COMMUNICATION AND NETWORKING RISER ECR FORM

ECR# (assigned internally): #006

Title of the Change: Increase Motherboard keep-out area

Specification Title and Version: CNR Specification, Version 1.0

Figure 1 – CNR Connector location for the ATX Family Form Factors

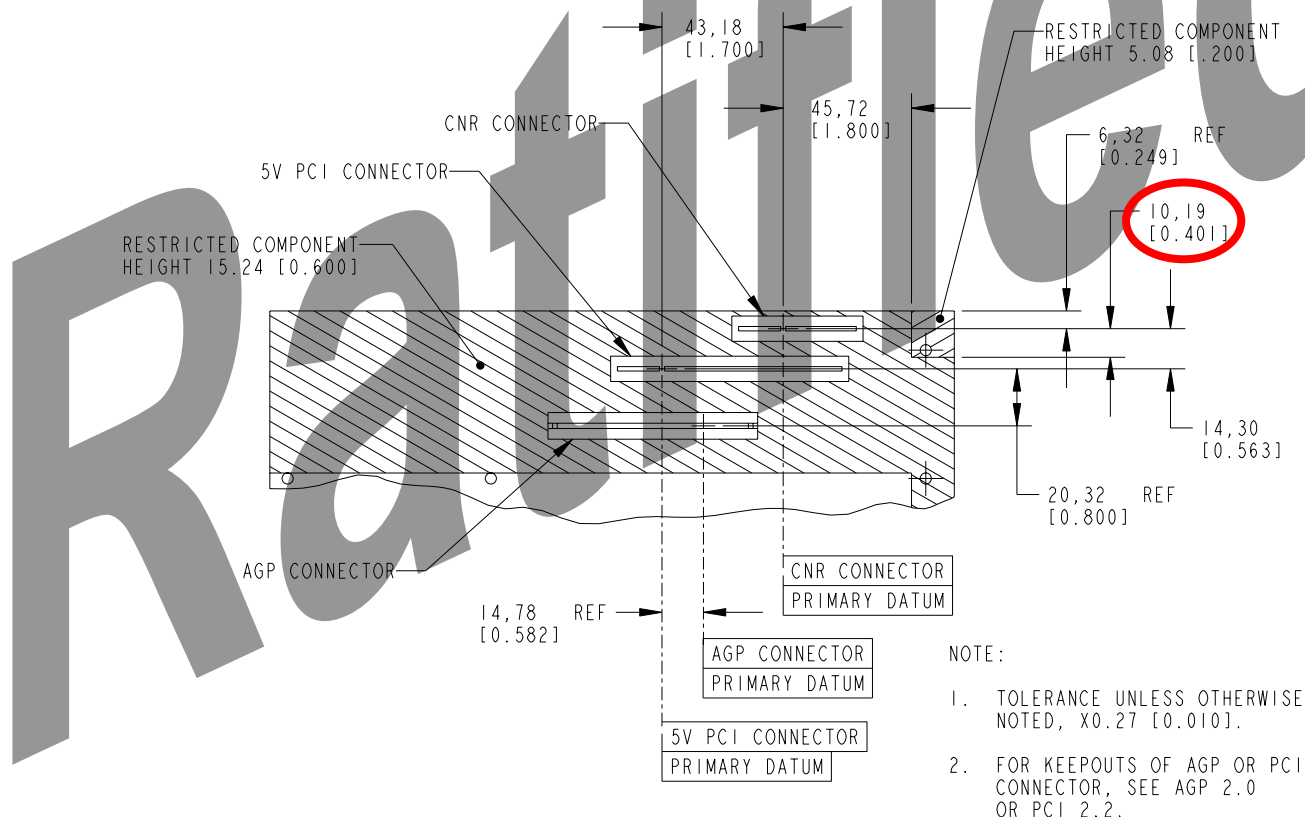
Designs on CNR have the capability to place parts near the bottom of the card in an area near the I/O Bracket. If parts are placed in this area they may interfere with components on the motherboard. In addition, this change further updates the CNR Specification to match the PCI Local Specification Revision 2.2.

Change the circled dimension shown in Figure 14 from 10,19mm [0.401 inches] to 15.38mm [0.605 inches]. This will insure that the keepout area on the motherboard is wide enough to accommodate the maximum component height on the primary side of the CNR card.
